Subject: KNOCKING / SQUEAKING NOISE FROM FRONT SHOCK ABSORBER, CREAKING NOISE FROM FRONT LOWER ARM BUSHING	Bulletin No: 02-010/16
	Last Issued: 04/05/2016

This bulletin supersedes the previously issued bulletin(s) listed below: The changes are noted in Red beside the change bars.

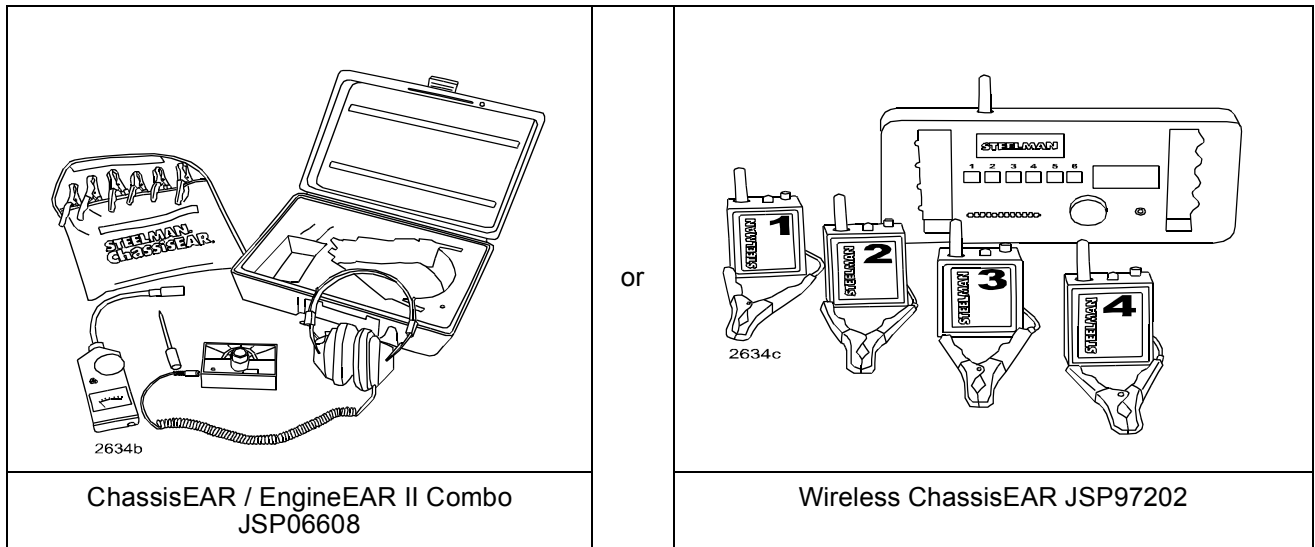
- upper front strut bearing (A) damage. (CX-5 and Mazda6)
- stick/slip between the front strut bearing and coil spring. (CX-3, CX-5 and Mazda6)
- the bump stopper (C) may be contacting the strut bearing when the front shock absorber is compressed, causing a popping noise. (Mazda6 only)
- The front lower arm bushing (D) is making a stick-slip noise in wet road conditions. (CX-5 and Mazda6)

1. The material and production method of the front strut bearing (A) has been changed. (CX-5 and Mazda6)
2. A protector has been installed onto the coil spring. (CX-5 and Mazda6)
3. The shape of the bump stopper (C) will be modified in the future. (Mazda6 only)
4. The shape of the coil spring has been changed. (CX-3 only)
5. Friction of the lower arm bushing has been reduced by adding a dry coating. (CX-5 and Mazda6)

NOTE: The piston rod nut (B) requires replacement.

Coil Spring Protector (A) Installation:

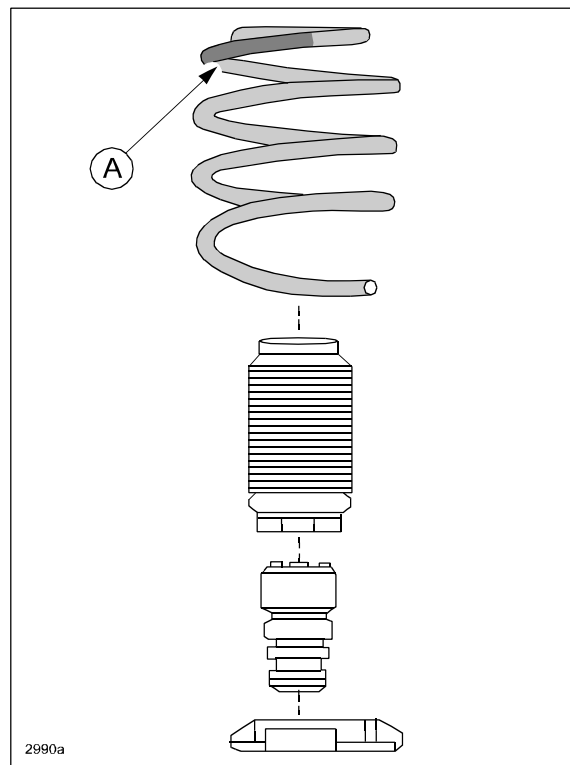
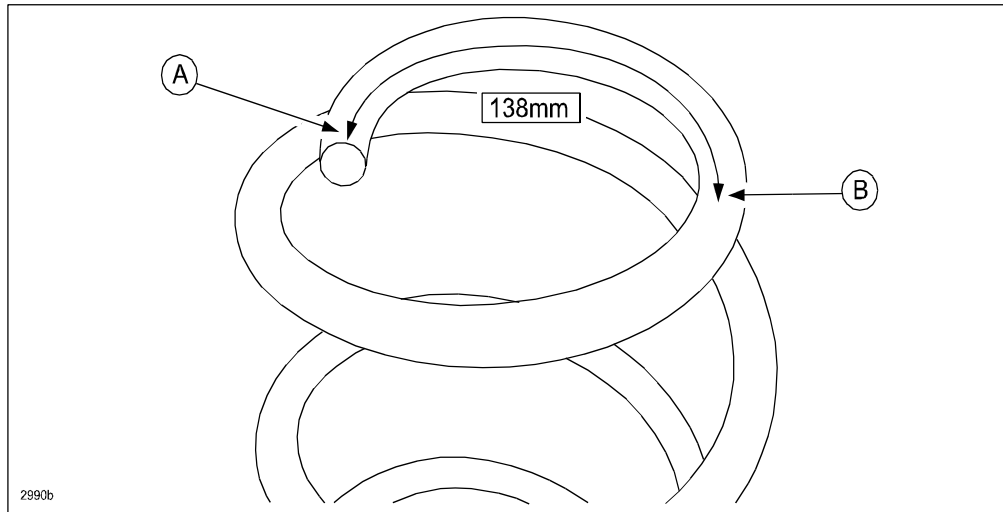
3. Starting from the top of the coil spring, decrease the spring 1.5 coils downward.

- Cut a thin strip of paper to 138 mm in length (or use a cloth type measuring tape).

NOTE: For CX-3, use 130 mm in length.

- Place the strip of paper (or cloth measuring tape) along the inner side of the coil spring starting at point (A).
- Mark the spot on the spring where (B) is. (B) is the starting point for the protector installation.

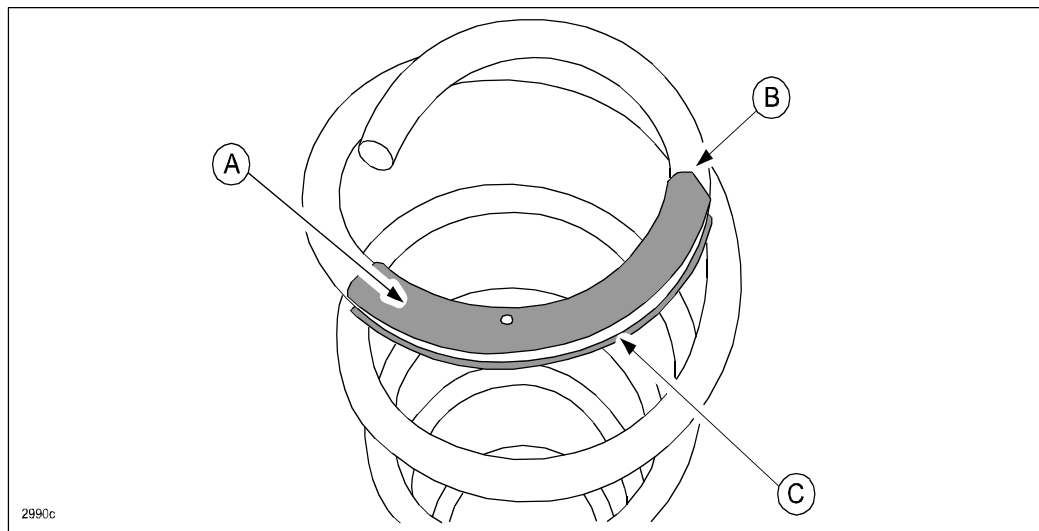
- Install the protector (A) onto the coil spring aligning the end (slant cut side) with the marking at spot (B).

NOTE: Install the protector so the gap (C) is evenly aligned around the outer edge of the coil spring.

Replace Bump Stopper (For all Mazda6 vehicles)

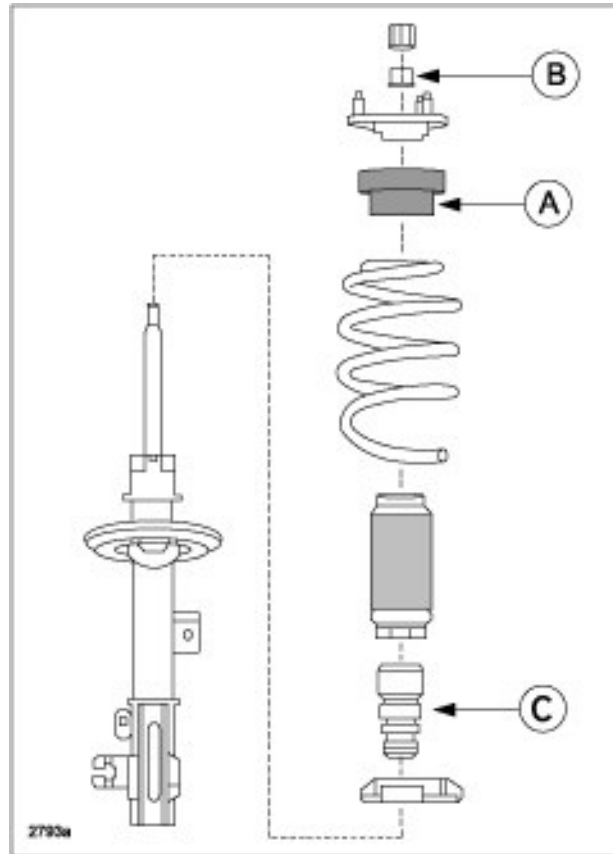
1. Remove the front strut bearing and coil spring according to MS3 online instructions or the Workshop Manual (section 02-13 FRONT SHOCK ABSORBER AND COIL SPRING DISASSEMBLY/ASSEMBLY).
2. Replace the bump stopper (C).

Replace Lower Arm Bushing (For Vehicle Type A, B and C)

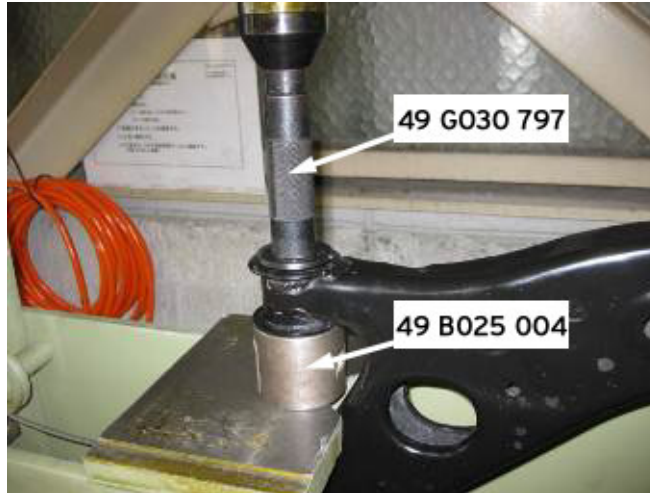
1. Remove the front lower arm (both sides) according to MS3 online instructions or the Workshop Manual (section 02-13 FRONT LOWER ARM REMOVAL/INSTALLATION).
2. Remove the front lower arm bushing using the SSTs.
Set SSTs (49 G030 797 and 49 B025 004) and the front lower arm on a shop press as shown in the figure and remove the front lower arm bushing.

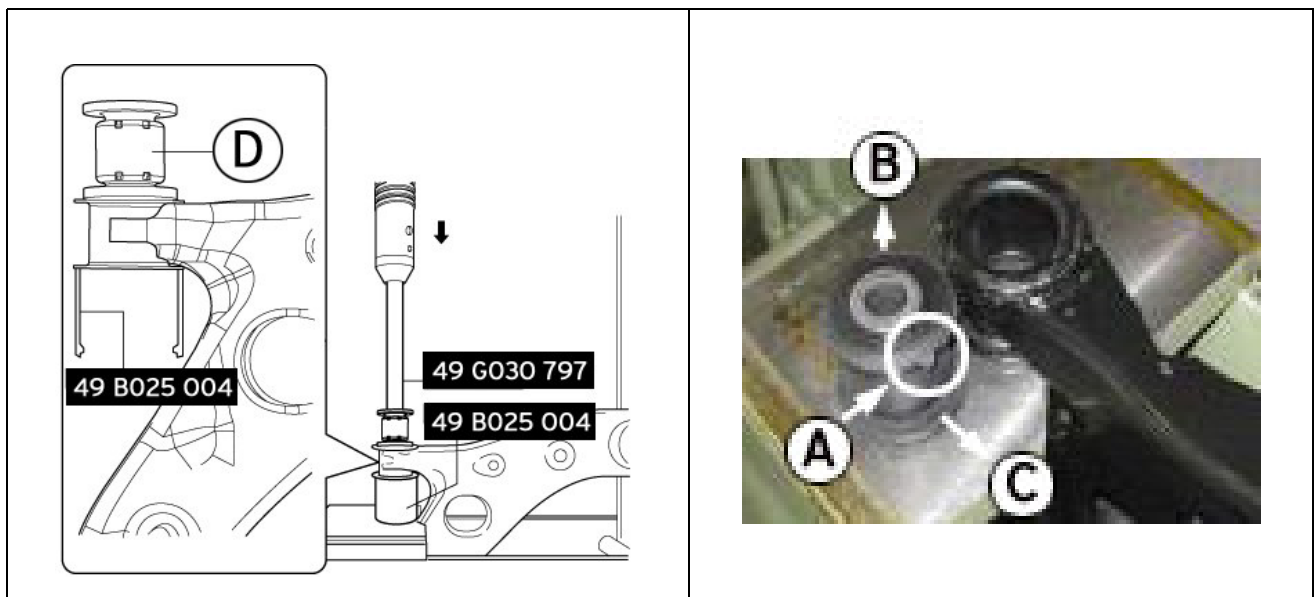
3. Install the front lower arm bushing (D) using SSTs.
Install the front lower arm bushing so that the projection (A) shown in the figure is pointing toward the front (B) and out of the vehicle (C).

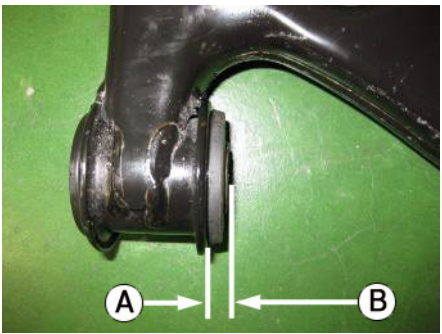
- After the installation, verify that the front lower arm bushing has been installed to the correct position by the procedure shown in the figure.

Measure the distance of the lower arm end face (A) and the inner pipe bushing (B).		Measure the width as shown

Specification: Width: 5.8 +/- 0.8mm (0.22 +/- 0.03 in)
